Downtown Victoria North Manchester.

RIBA Stage 4 Planning Adjustments
12882-AEW-XX-XX-PP-A-0017

BS / BR 09/02/24
P01

Introduction.

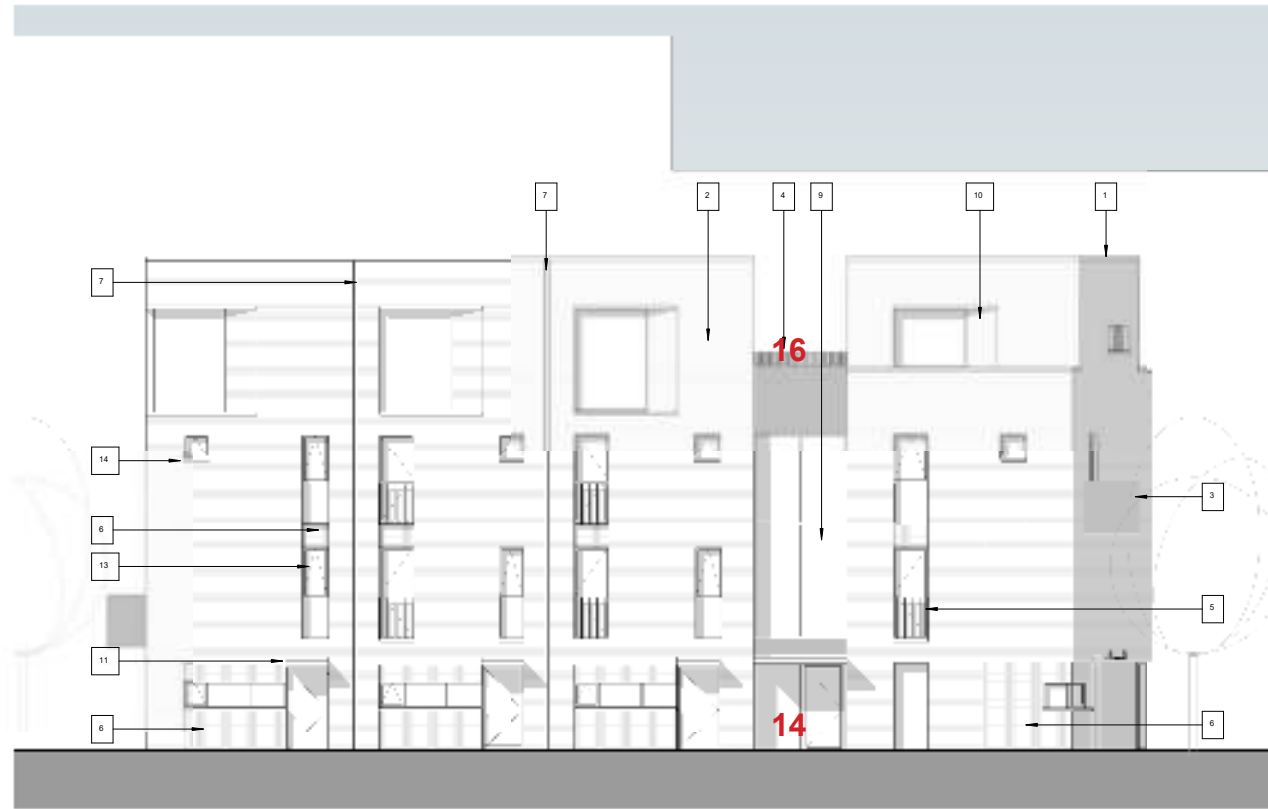
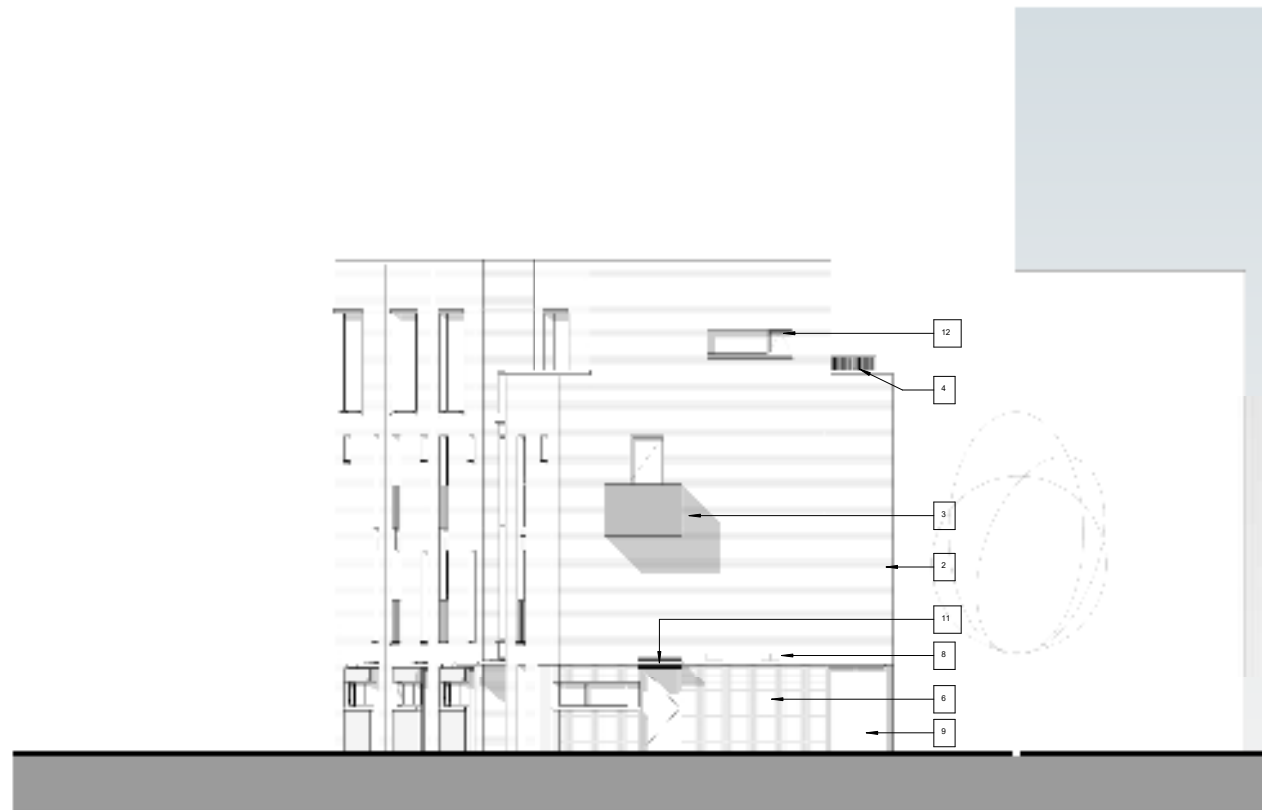
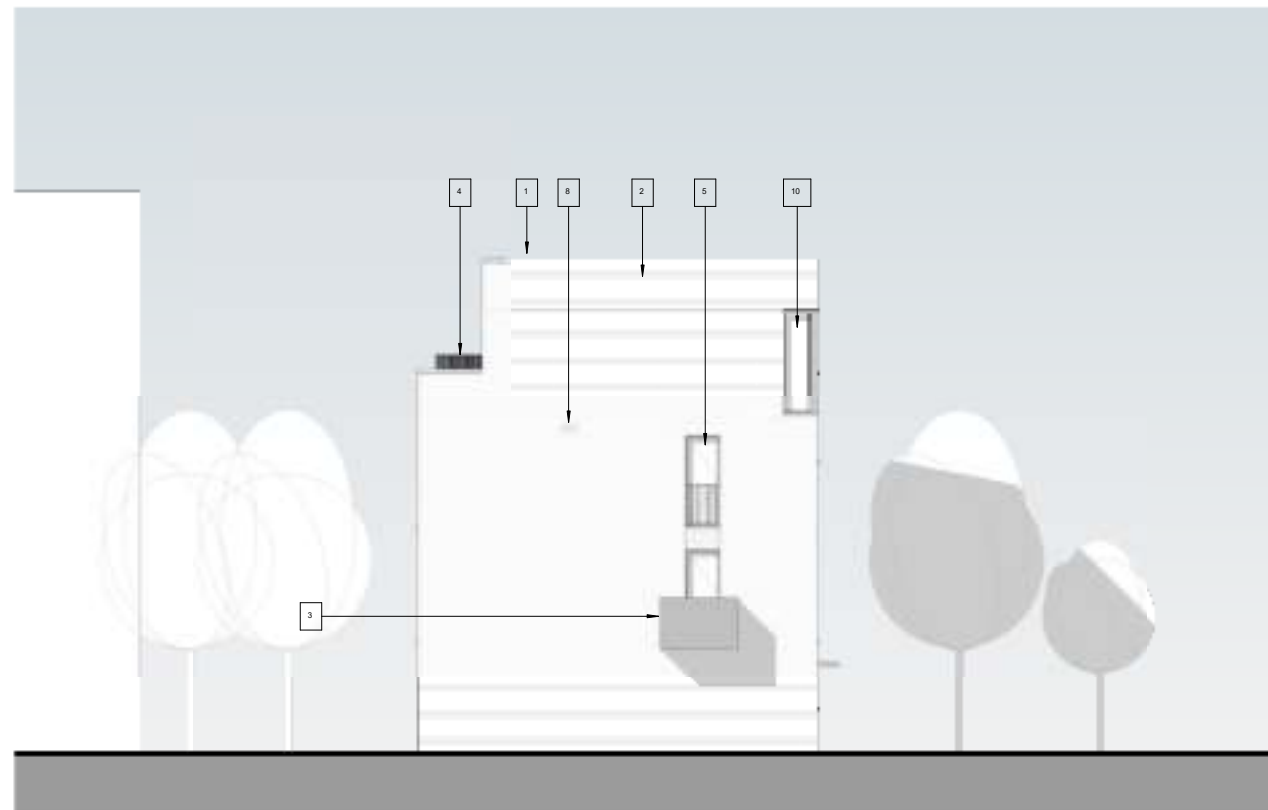
13 Spandrel panel included within curtain wall to provide fire separation - matching reasons of item 2 on Block 1 & 2

14 Building entrance recess reduced by 225mm to enable stair and service riser to function.

15 Areas that were previously external are converted to internal space follow development of SAP assessment, thermal strategy, insufficient floor zones to accommodate insulation / cold

16 Additional edge protection provided due to insufficient height of parapet. Proposed metal railings match other balustrade proposals

17 Airbrick introduced to match Block 1 & 2 to suit ventilation requirements

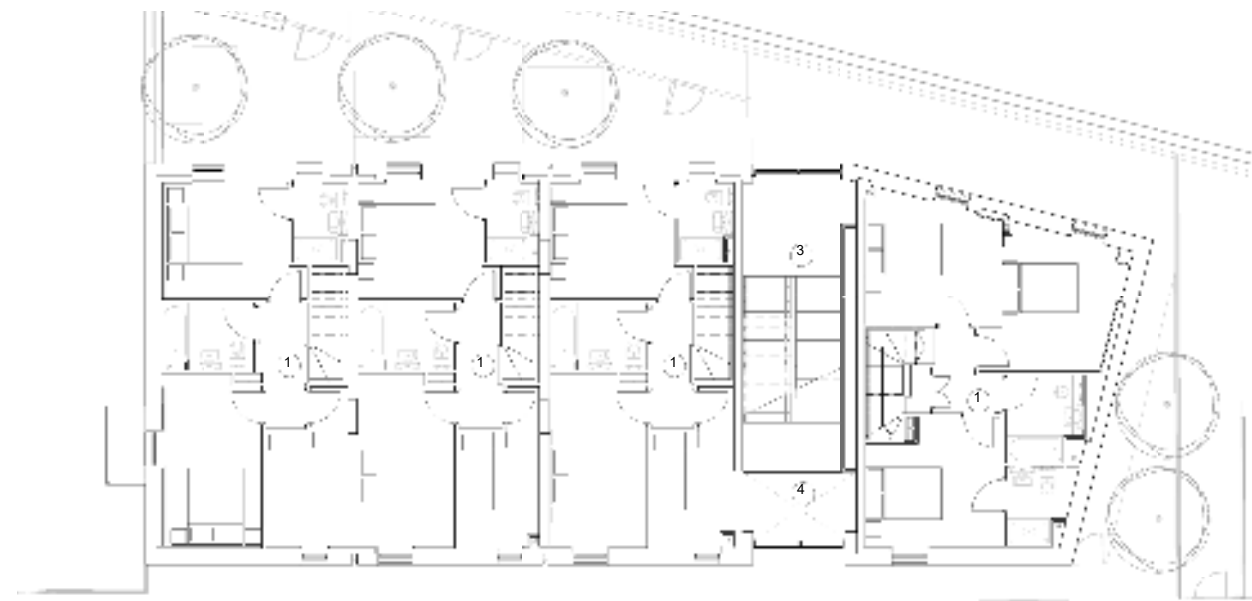
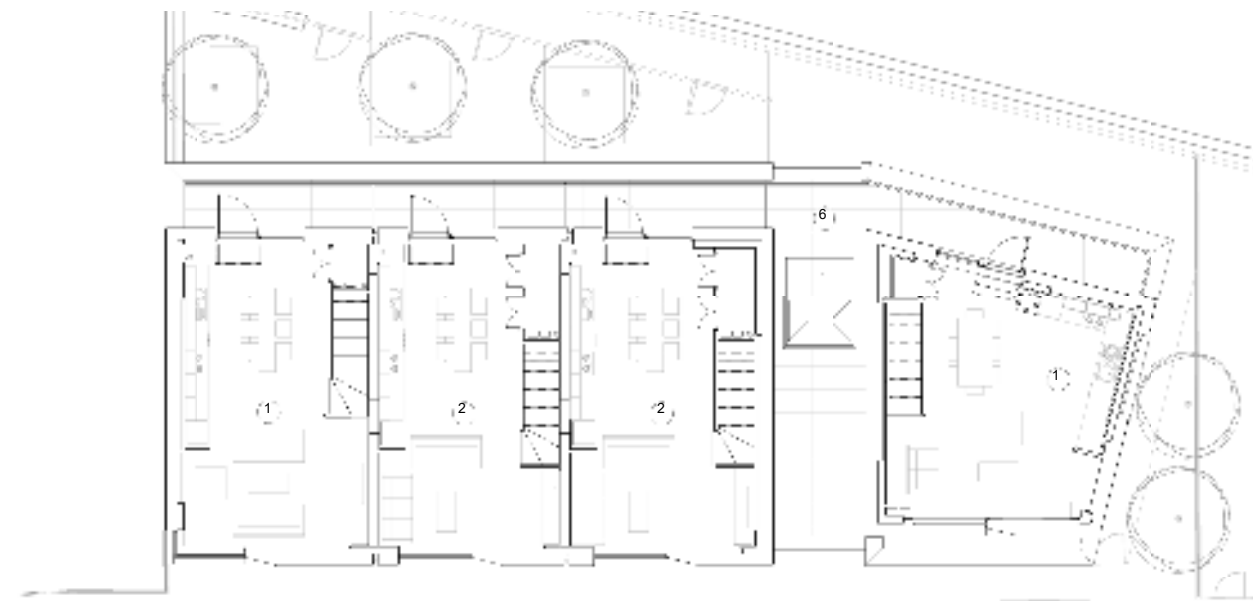
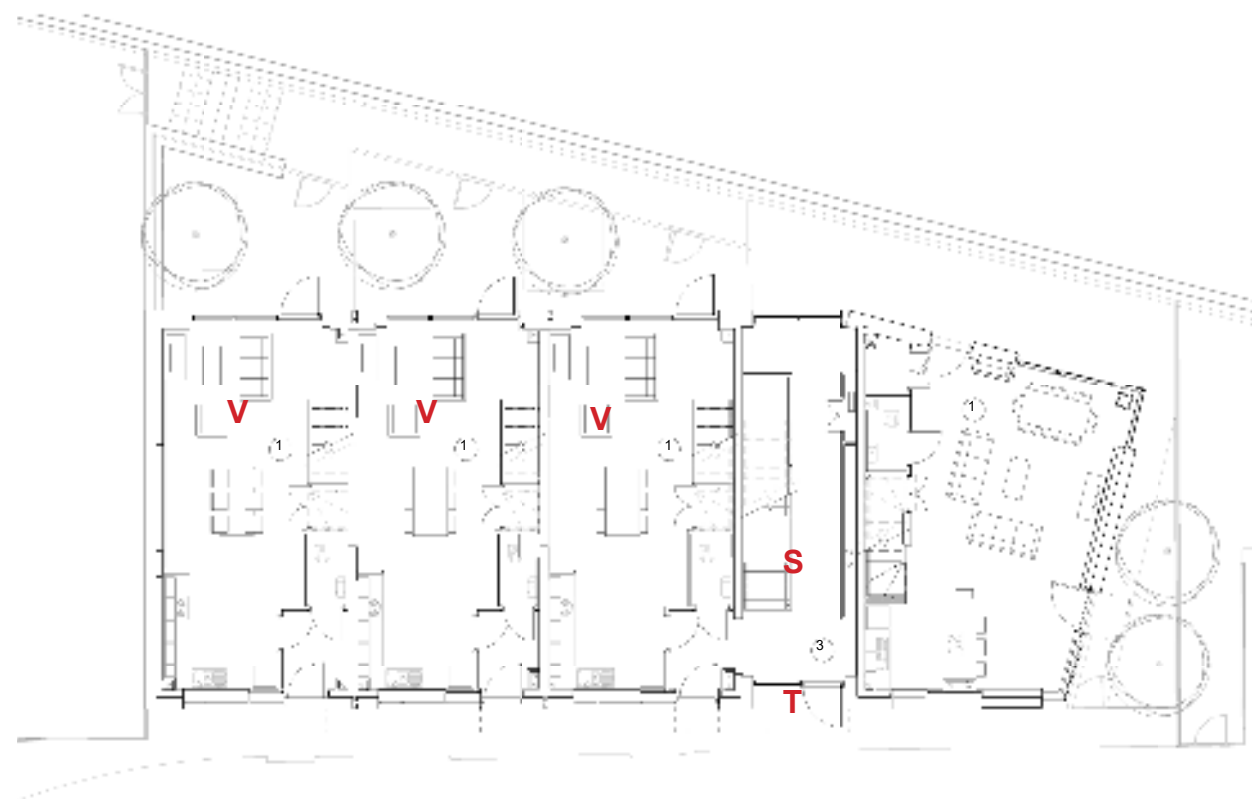
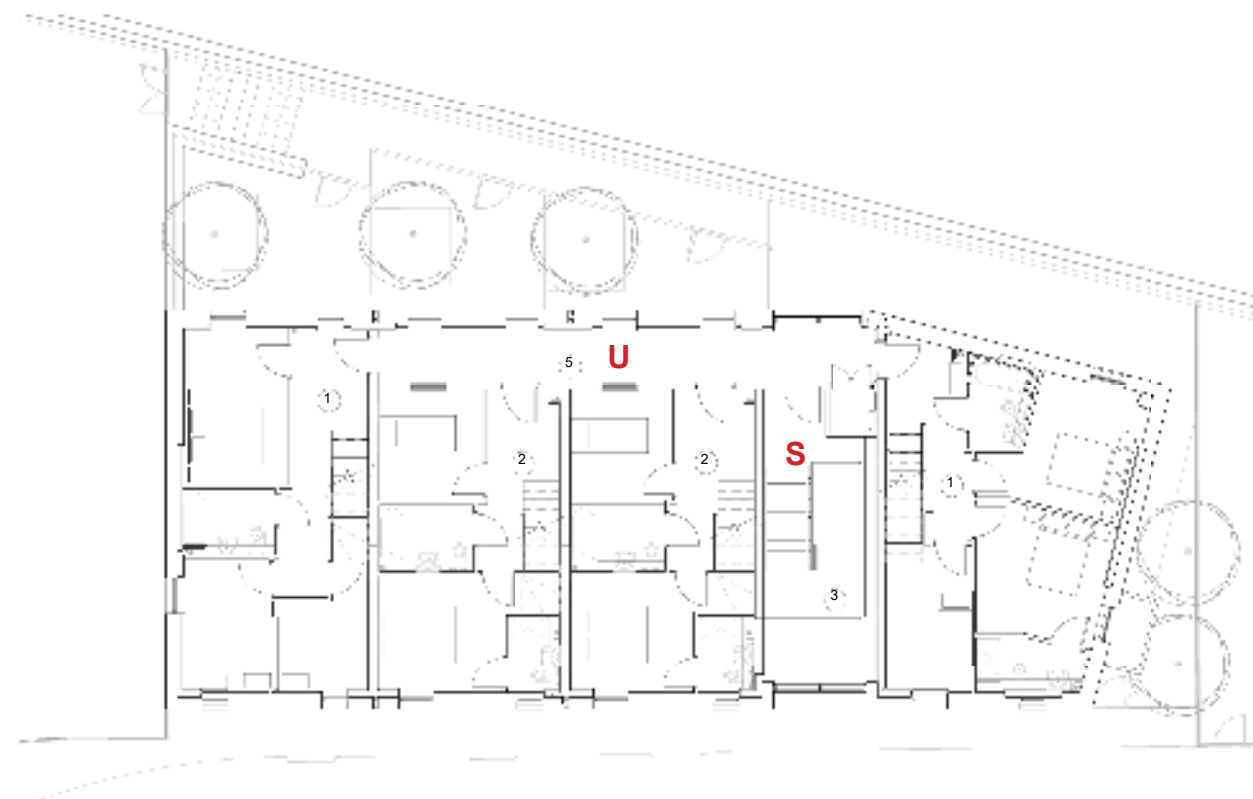
S Central stair re-configured to allow developed MEP design and cleaning / access of curtain walling

T Building entrance recess reduced by 225mm to enable stair and service riser to function.

U Areas that were previously external are converted to internal space follow development of SAP assessment, thermal strategy, insufficient floor zones to accommodate insulation / cold

V Internal elements re-configured following development of fire strategy in-conjunction with fire engineer and building control
